Eagle Mountain Pumped Storage Project – Landfill Compatibility

Prepared by: Richard Westmore, P.E., GEI Consultants, Inc. and Ginger Gillin, GEI Consultants, Inc.

April 8, 2009, revised November 24, 2009 and August 13, 2012

January 2011 update: Response to Additional Comments from Kaiser and Others in Review of the July 2010 Draft Environmental Impact Report.

LANDFILL COMPATIBILITY PLAN DLA LAYOUT

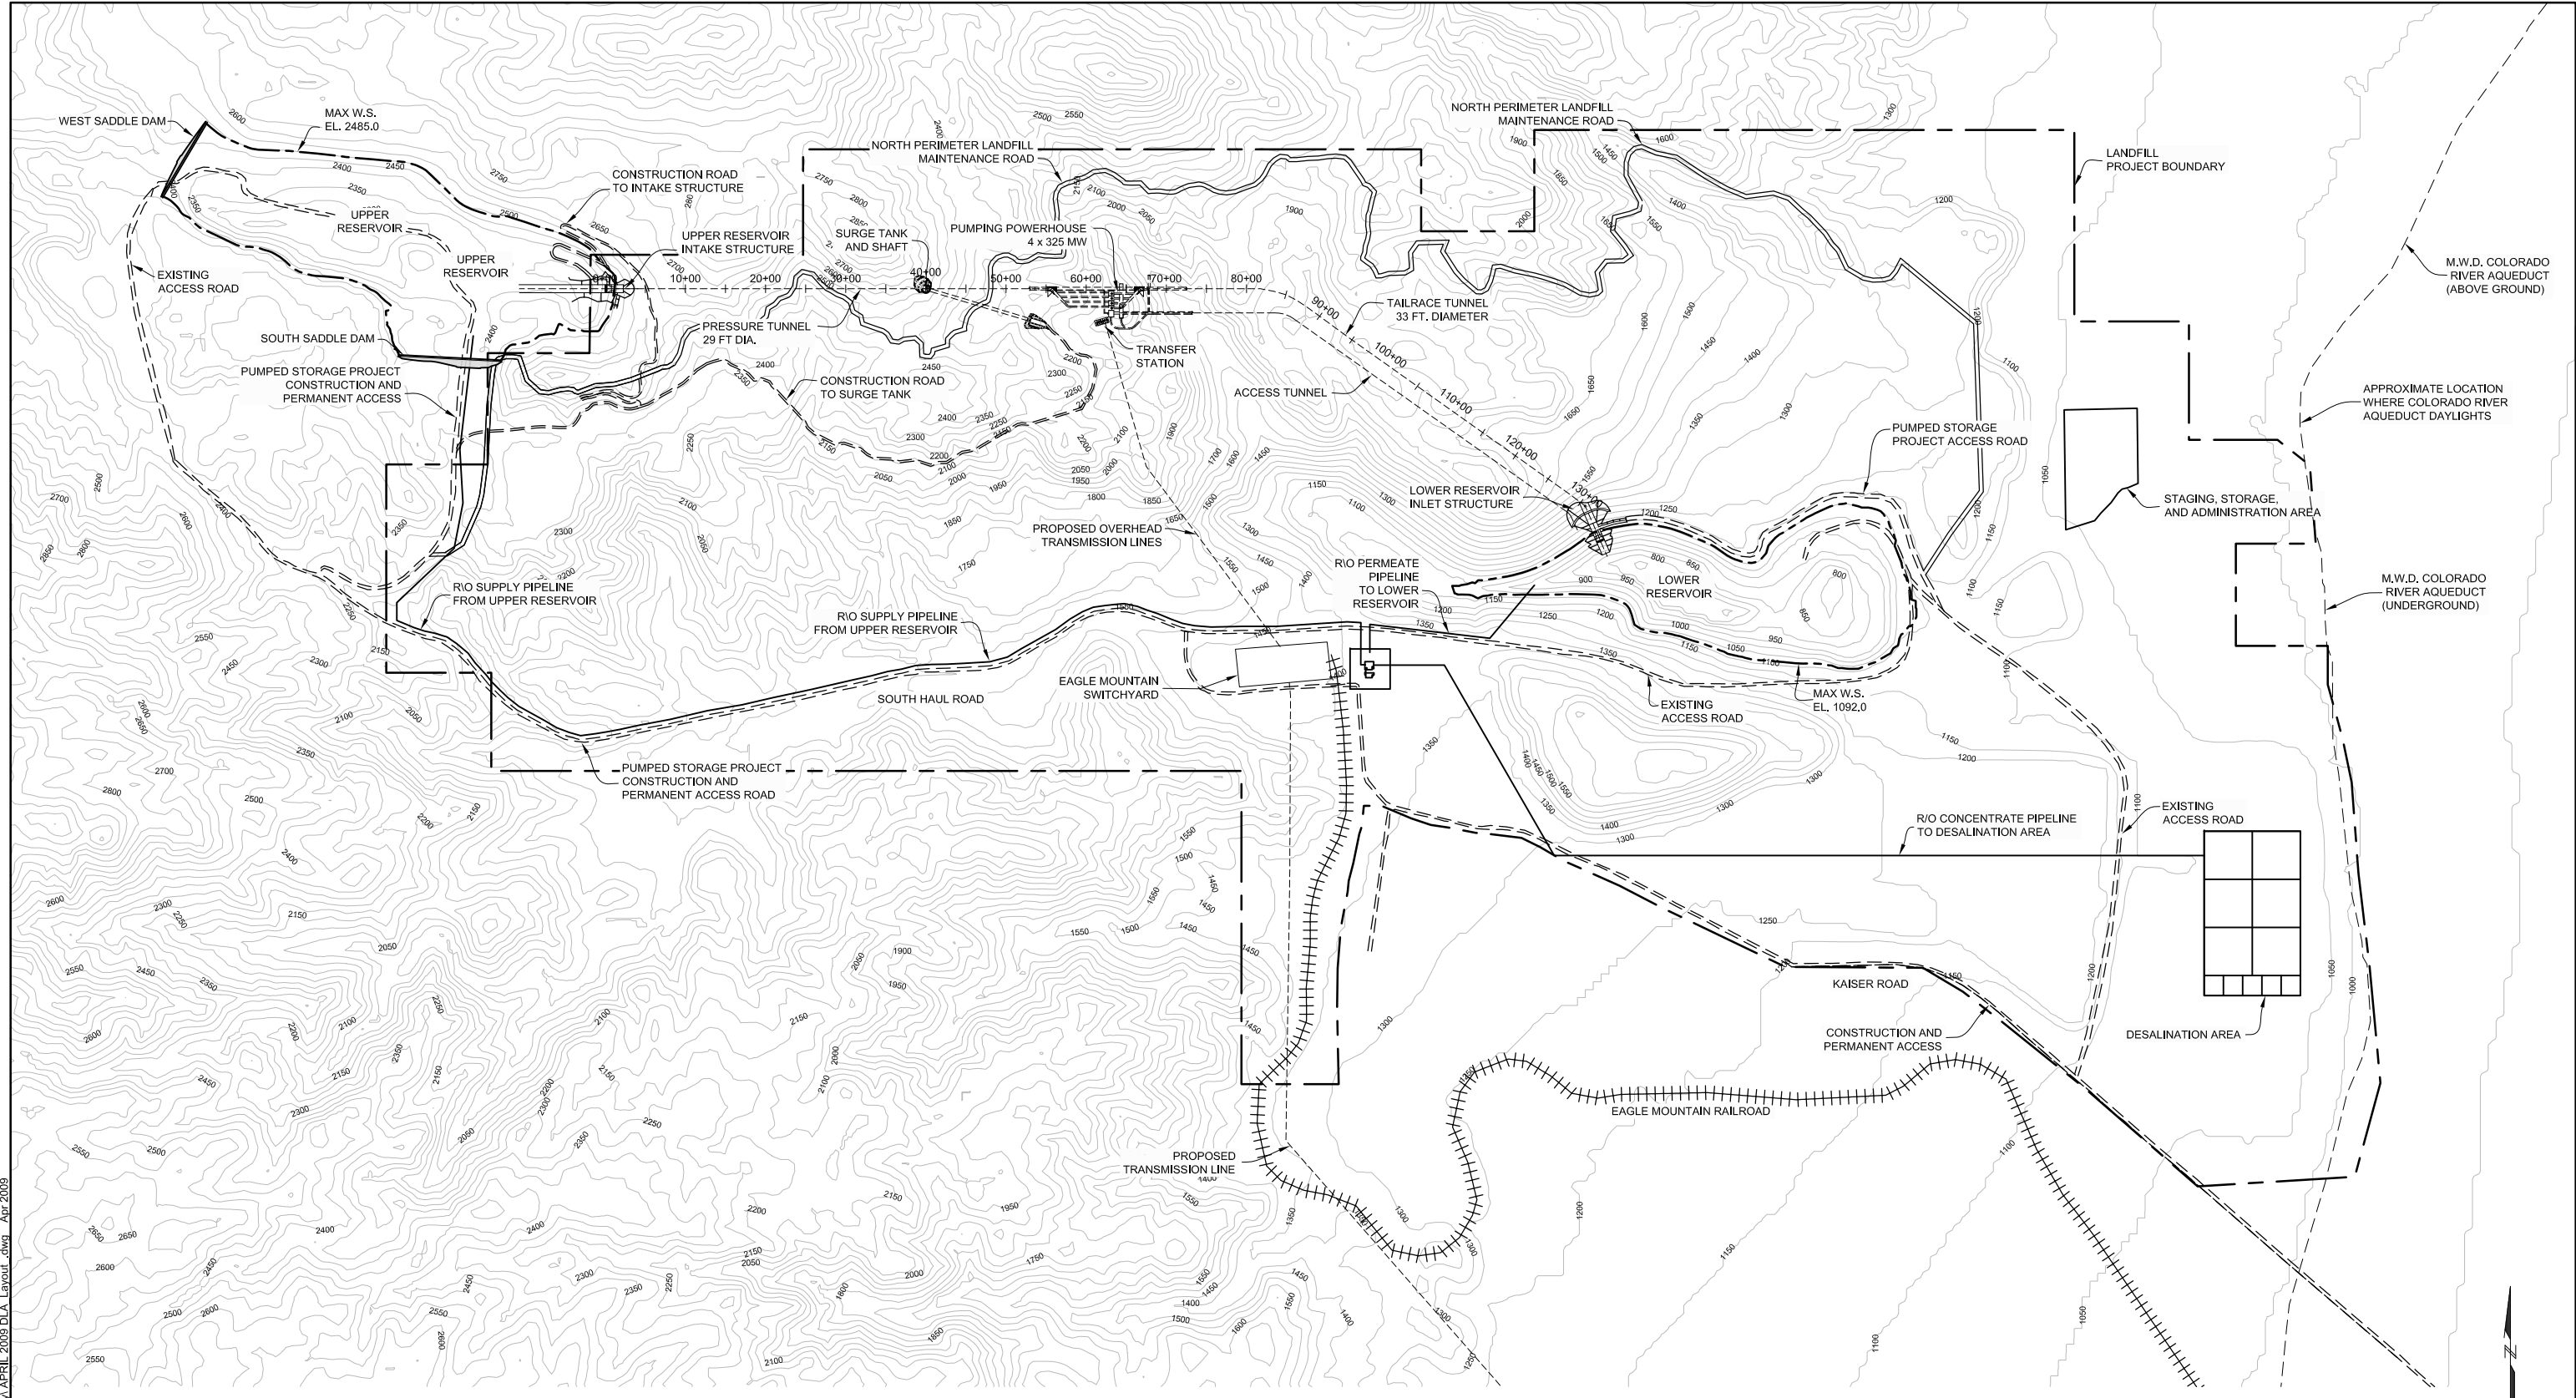
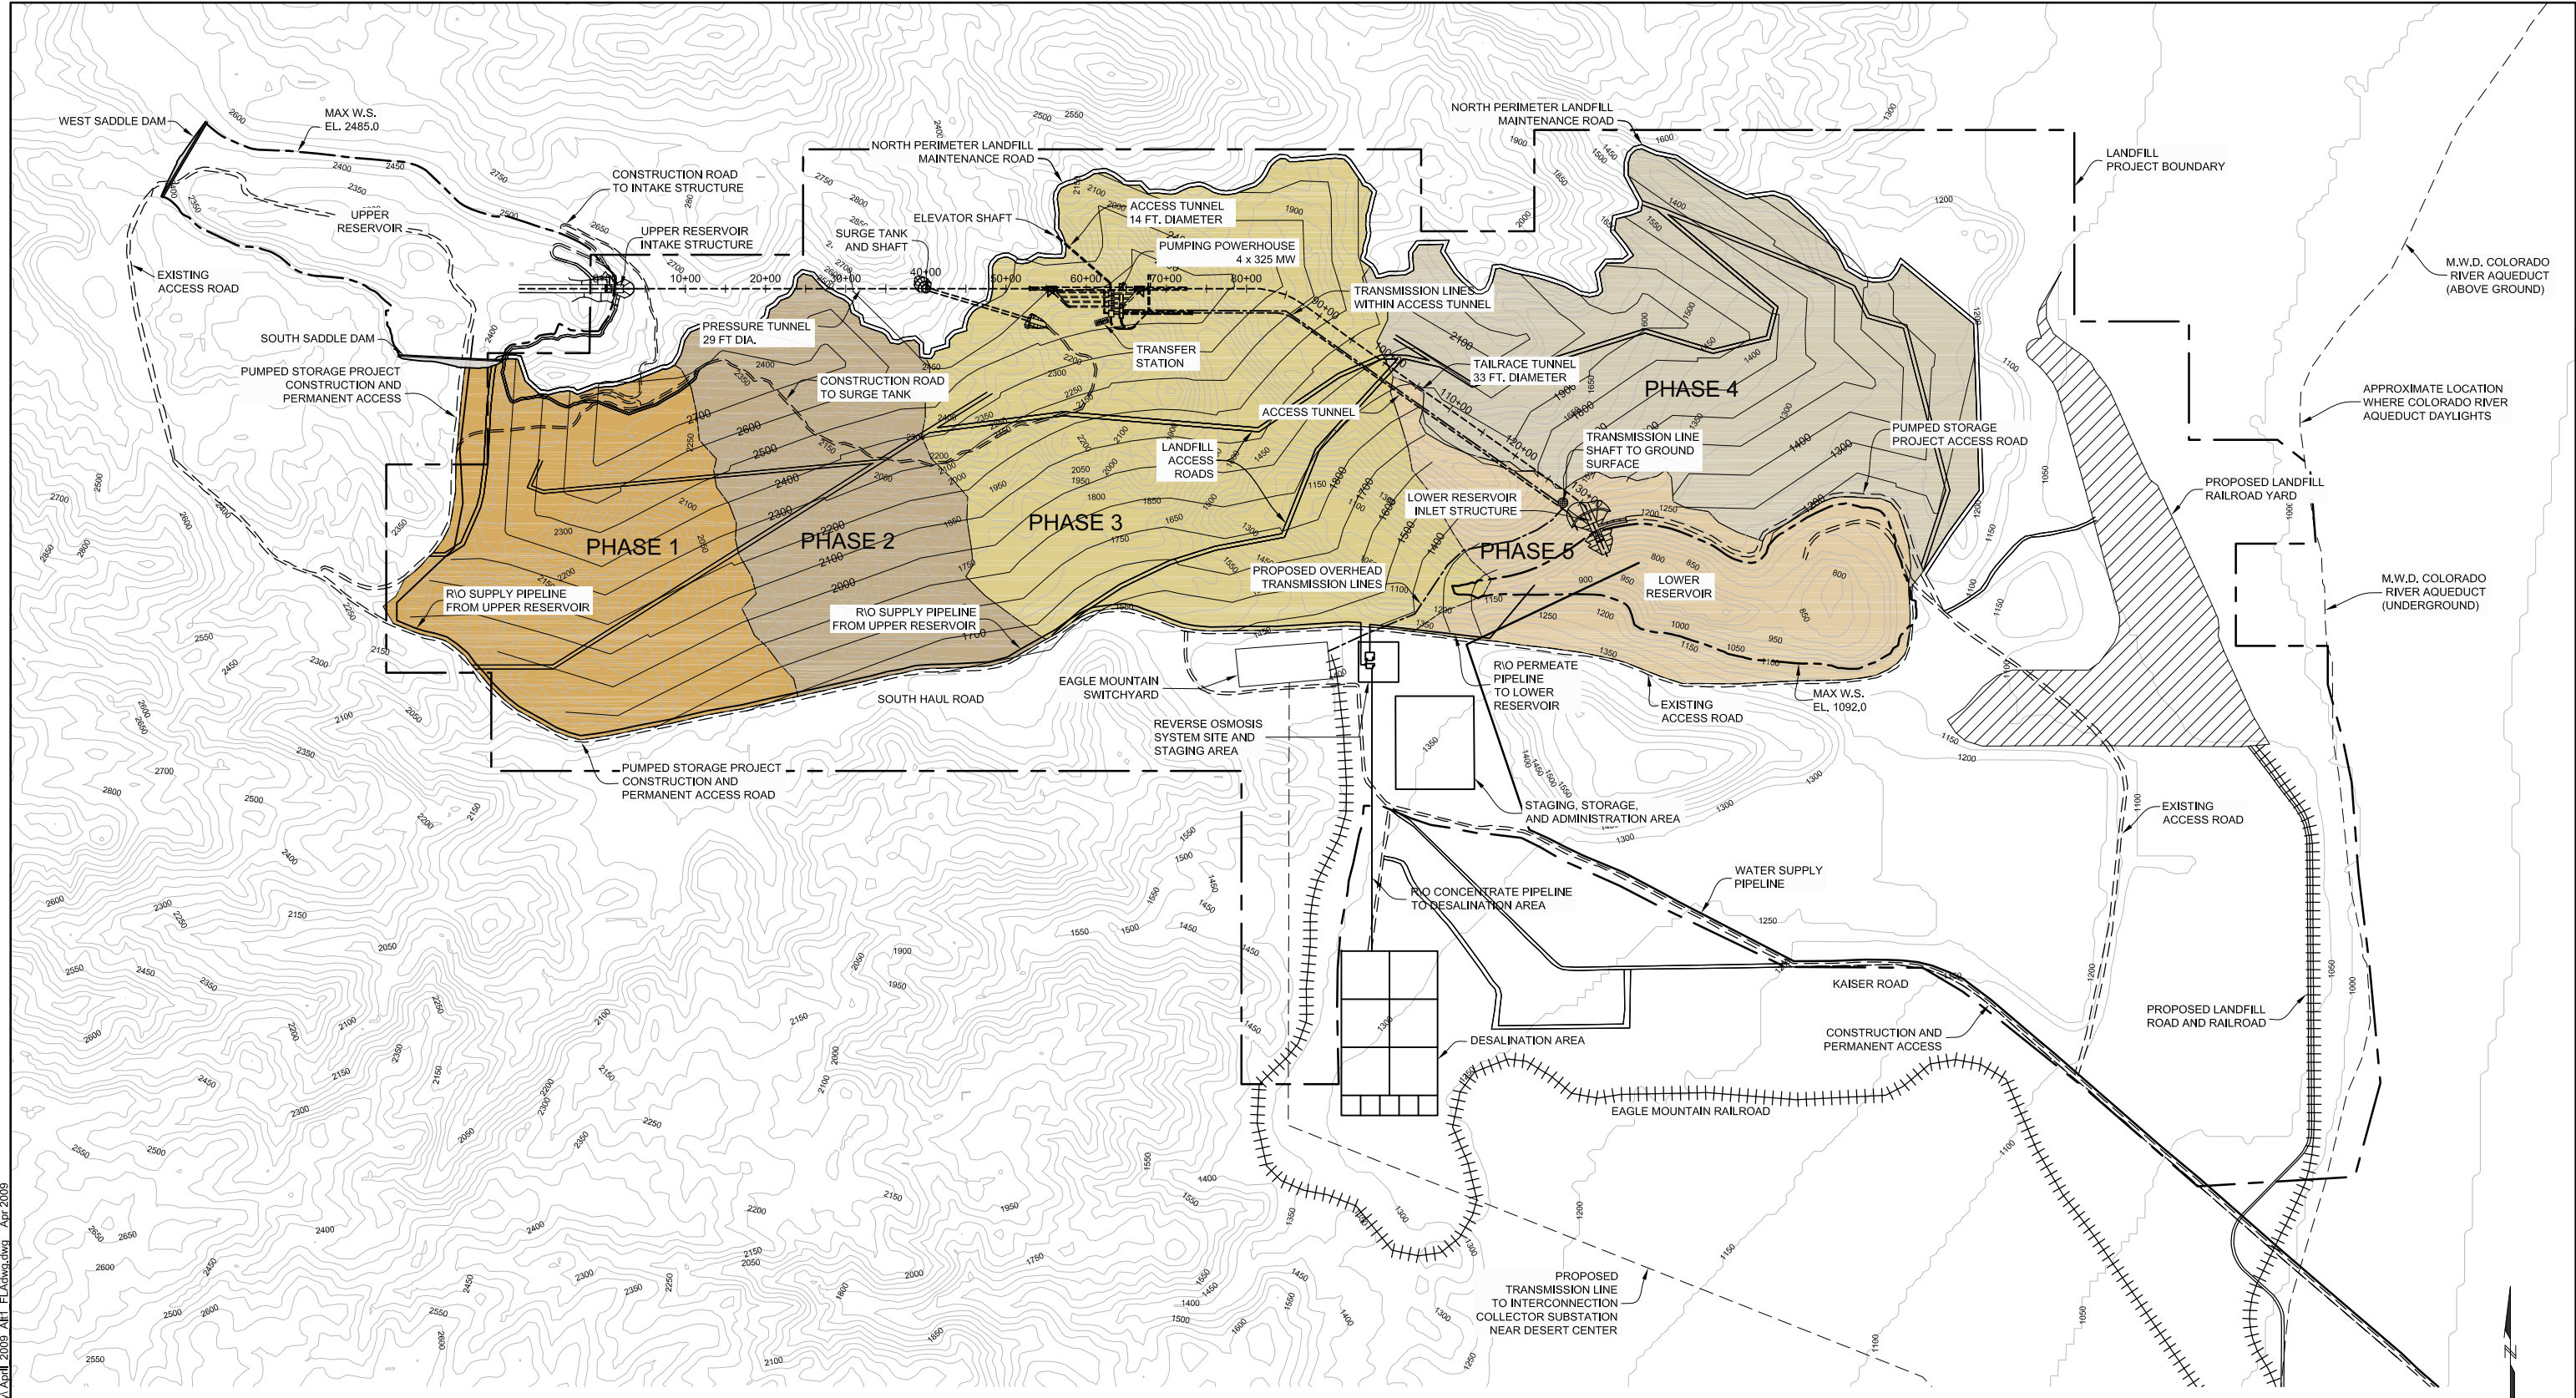
- *Pumped storage facilities would hinder or prohibit development of the truck marshalling yard and portions of the rail yards.*
- *The above-ground transmission line from the underground powerhouse to the Eagle Mountain switchyard would reduce Phase 3 landfill disposal capacity.*
- *The pumped storage project tunnels are aligned below the landfill Phases 2, 3 and 4 and could affect landfill liner integrity.*
- *The use of fine tailings from the mine for lining of the proposed reservoirs to control seepage may conflict with use of these fine tailings for the landfill.*
- *The DLA did not indicate how interference and compatibility issues will be addressed and does not credit the advanced design level (estimated to be 70% complete) for the landfill project relative to re-securing approvals if the landfill designs are changed to accommodate the pumped storage project.*

The DLA showed the low-voltage cable connection from the powerhouse to the Eagle Mountain switchyard as an above-ground line. The transmission lines connecting the transfer station and the switchyard were originally placed above ground through the Phase 3 portion of the landfill project. This layout (from the DLA) is shown in Figure 1. The line would have extended from the top through a vertical cable shaft, above ground to the switchyard. ECE now intends to route the low-voltage cables from the underground powerhouse through the underground powerhouse access tunnel (Figure 2). The transmission cables would only be located above ground from the access tunnel portal near the lower reservoir, along the north rim of the reservoir and adjacent to the proposed water pipeline from the reverse osmosis treatment plant to the lower reservoir. The water treatment facilities have also been relocated from the location shown in the DLA to address concerns raised by the Metropolitan Water District (MWD) of Southern California.

Figure 1 presents the pumped storage facilities as they were depicted in the Draft License Application (DLA) dated June 22, 2008. Based on that presentation and comments on the DLA offered by Kaiser Eagle Mountain LLC and Mine Reclamation LLC (the landfill proponents collectively called “Kaiser”) and the Los Angeles County Sanitation District No. 2, FERC requested Eagle Crest Energy Company (ECE) to include in its Final License Application (FLA) documentation to support the conclusion that the landfill project and the pumped storage project are compatible (i.e., neither project would interfere with the construction or operation of the other) as stated in the FLA (see FERC letter dated September 15, 2008).

LANDFILL COMPATIBILITY FLA LAYOUT - CROSS SECTION

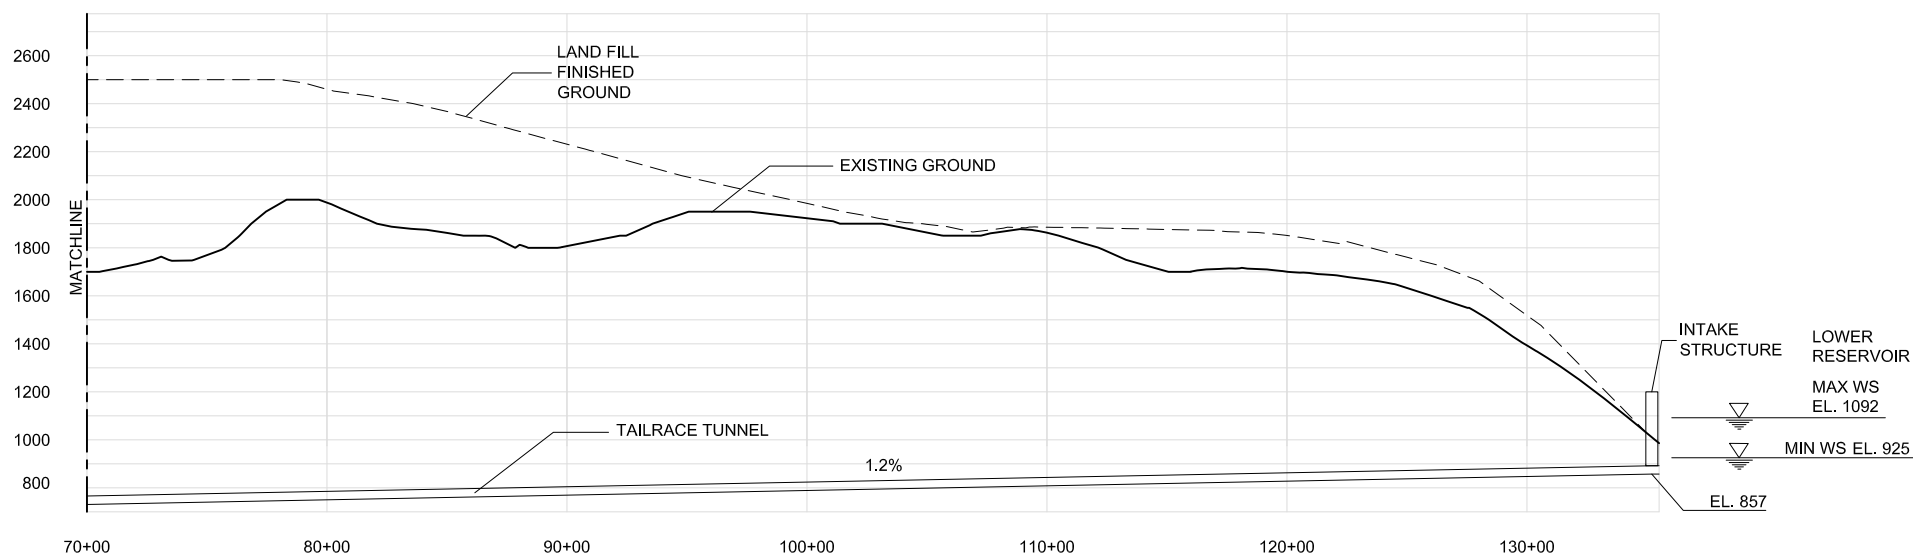
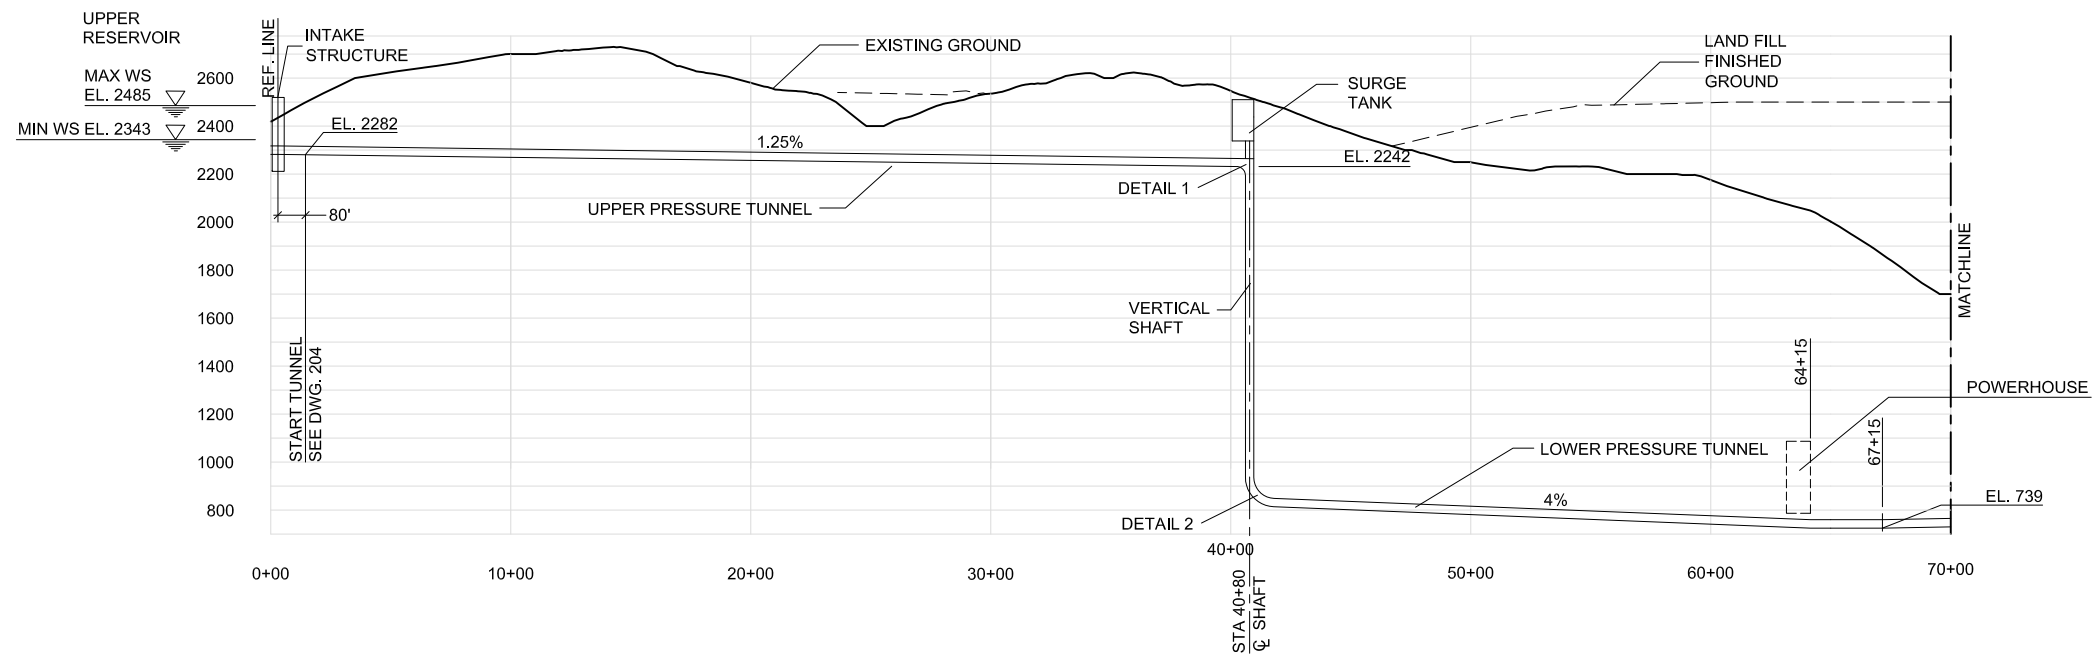
Kaiser's concerns with the water conveyance tunnels relate to the potential for seepage from the tunnels to impact the landfill liner system. The lower pressure tunnel and tailrace tunnel will be located generally 1,000 – 1,500 ft below ground, far beneath the landfill liner. Maximum operating pressure within the main conveyance tunnel will be approximately 700 psi. Final tunnel design will need to carefully consider water pressures acting on the tunnels in both directions when the tunnels are fully pressurized for hydroelectric operations and when they are dewatered for inspection. The final designs for the tunnels and associated tunnel linings will assure that no potential will exist for water from the project to cause uplift loads on the landfill liner system.

Concerns have been expressed that seepage from the upper reservoir and from the water conveyance tunnels could potentially impact the landfill. Studies by GeoSyntec (1996) indicate that the natural groundwater flow is initially to the south from the area of the central pit. Those studies also indicated that because of fractures in the bedrock, seepage will occur, particularly if the reservoir is not treated to control the rate of seepage. Therefore, the proposed pumped-storage operations may artificially raise groundwater levels in this local area. In the case of consistently high reservoir levels and efficient interconnectivity of bedrock fractures to the south, there is potential that this groundwater could exit on the hillside south of the upper reservoir, rather than staying beneath the existing ground surface and the landfill. With the landfill proposed to be constructed south (down-gradient) of the upper reservoir, this groundwater could potentially encounter the lining of the landfill.

The proposed FLA pumped storage layout, shown on Figure 2 (with proposed finished landfill contours), aligns transmission lines within the access tunnel where they will be protected from moisture, down to near the lower reservoir inlet structure. Here, the lines will run up through a shaft to the ground surface and then continue on to the Eagle Mountain switchyard as overhead transmission lines. Cables will run from each of the four 500/18 kV, 135 MVA transformers through the access tunnel and then above ground on towers to the switchyard. The total length of each cable will be approximately 10,000 feet and each will be rated as indicated for the transformers. The cable runs in the tunnel will be approximately 6,000 feet long and above ground the length will be approximately 4,000 feet. A profile view of this alignment is shown in Figure 3, FLA Layout – Cross Section.

The pumped storage facilities are located primarily underground at depths ranging from 100 to 1,500 feet below the existing ground surface and the proposed bottom liner for the landfill. This relationship is shown on Figure 3, which presents cross-sections showing the relationship between the tunnels and the landfill.
